**Subject: Oconee Nuclear Station
Docket Nos. 50-269, -270, -287
Responses to Request for Additional Information for the Proposed License
Amendment Request to Fully Credit the Standby Shutdown Facility and to
Eliminate Crediting the Spent Fuel Pool to High Pressure Injection System
Flow Path for Tornado Mitigation,
License Amendment Request No. 2001-012**

DUKE RESPONSES TO RAI IN REGARDS TO PROPOSED LICENSE AMENDMENT REQUEST TO FULLY CREDIT THE STANDBY SHUTDOWN FACILITY AND TO ELIMINATE CREDITING THE SPENT FUEL POOL TO HIGH PRESSURE INJECTION SYSTEM FLOW PATH FOR TORNADO MITIGATION, OCONEE NUCLEAR STATION, UNITS 1, 2 AND 3

Figure 1 - Distribution of Tornadoes by Month and Intensity

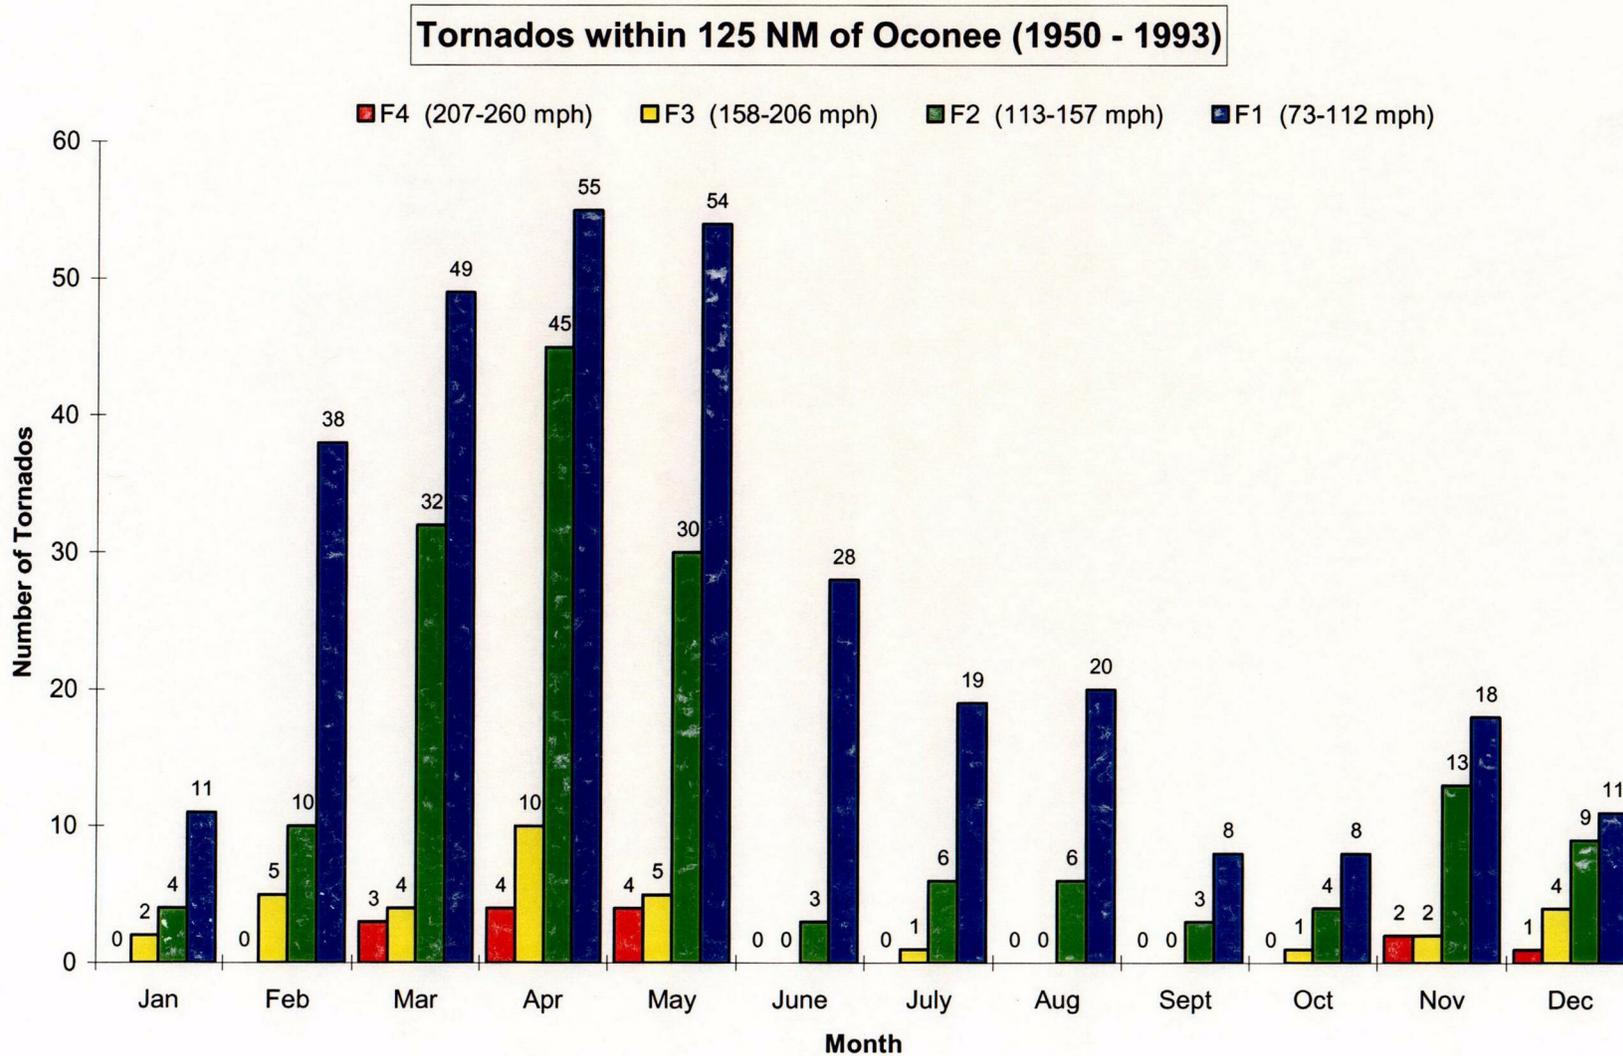
- d. Provide a graph that shows the probability of tornado occurrence at the Oconee Station vs. Time of Year, and explain how operability of the SSF will be assured and maintained during periods when the probability of tornado occurrence is relatively high.

Figure 1 provides a graph of the seasonal distribution of tornado occurrences for the region surrounding the Oconee site. This graph clearly shows that the months of March, April, and May have a significantly higher occurrence rate and a higher number of high-intensity (F-3 and F-4) tornadoes. The equivalent tornado strike frequency during these months is roughly twice the average annual strike frequency.
